Docket Number:	15-AFC-01
Project Title:	Puente Power Project
TN #:	205765
Document Title:	Applicant's Responses to CEC Data Requests Set 1 (1-47)
Description:	N/A
Filer:	Paul Kihm
Organization:	Latham & Watkins LLP
Submitter Role:	Applicant Representative
Submission Date:	8/17/2015 4:55:23 PM
Docketed Date:	8/17/2015

Puente Power Project (P3)
Oxnard, CA

Responses to CEC Data Requests Set 1 (1-47)

As-built Drawing for the Rework of MGS Aqueous Ammonia Storage Tank

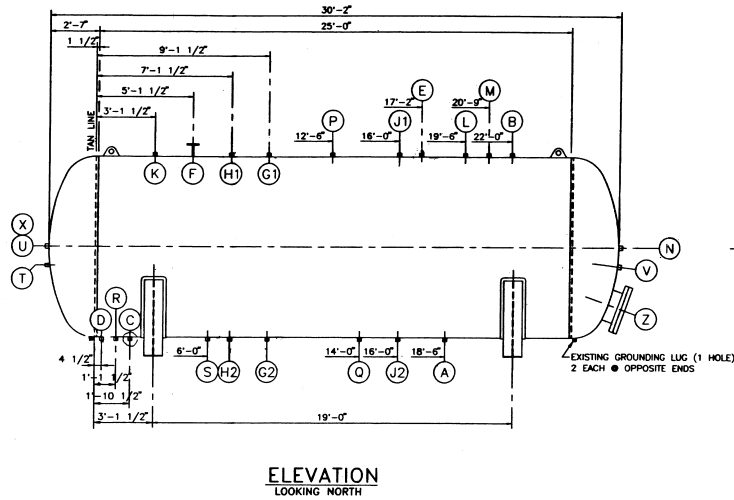
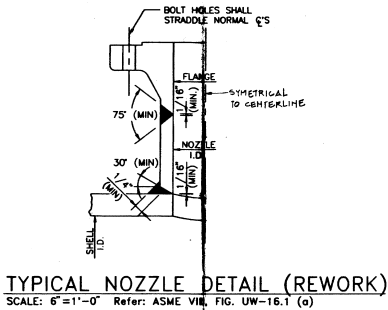
- 14. Please provide the current age of the existing tank along with a narrative demonstrating that the tank is compliant with API 620.***

As shown on the as-built drawing for the ammonia tank (see Appendix B-2), the “reworked” tank for the storage of 29.4 percent aqueous ammonia was built to the ASME Section VIII code, which is a more stringent code than API-620.
